# Service Bulletin

Bulletin No.: 07-08-59-007A

**Subject:** Front/Rear Door Creak/Squeak Noise When Opening or Closing (Apply Squeak Reduction Tape)

**Models:** 2008-2014 Buick Enclave  
2009-2014 Chevrolet Traverse  
2007-2014 GMC Acadia  
2007-2010 Saturn OUTLOOK

1992433

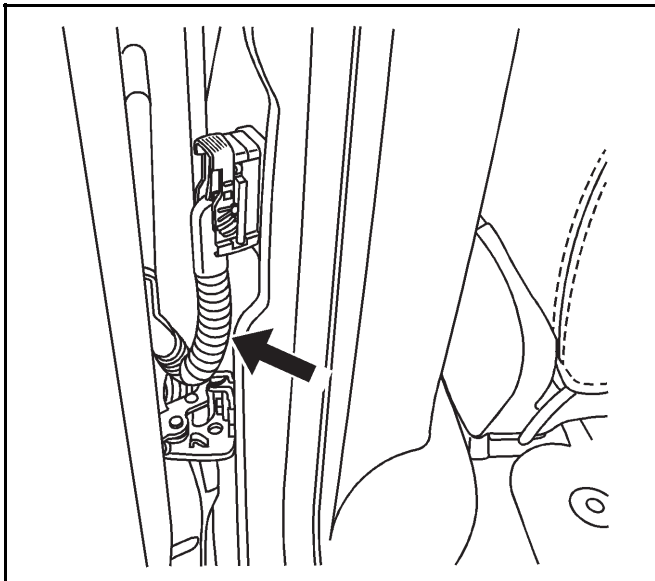
The front/rear door rubber conduit may be coming in contact with the "A" or "B" pillar (at arrow) when opening or closing. Refer to the illustration above. Shown: Right front door open, looking at right rear door connector.

1993209

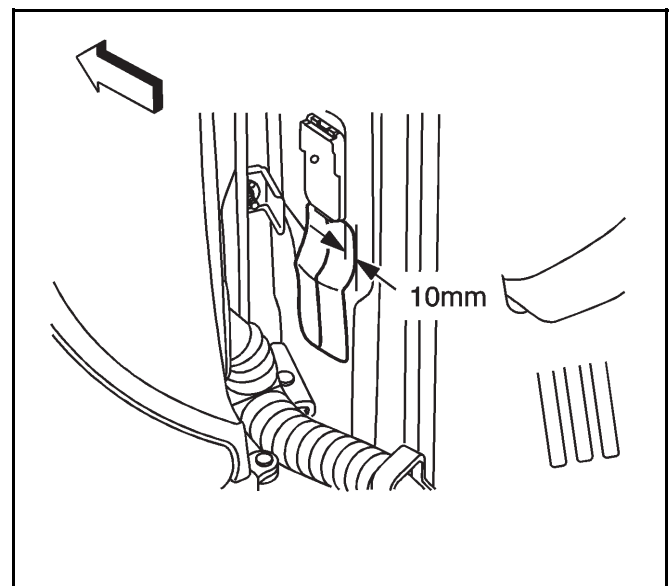
1. Open the door and clean the "A" or "B" pillar.
2. Disconnect the battery.
3. Disconnect the door electrical connector.

4. Install two strips side by side, 100 mm (4 in) long, of 3M™ Squeak Reduction Tape, P/N 06356, or Kent Automotive Anti-Squeak Film Tape, P/N KT13512. Install the two strips of squeak reduction tape just below the wire harness connector and 10 mm (3/8 in) rearward of the connector. Refer to the illustration above.
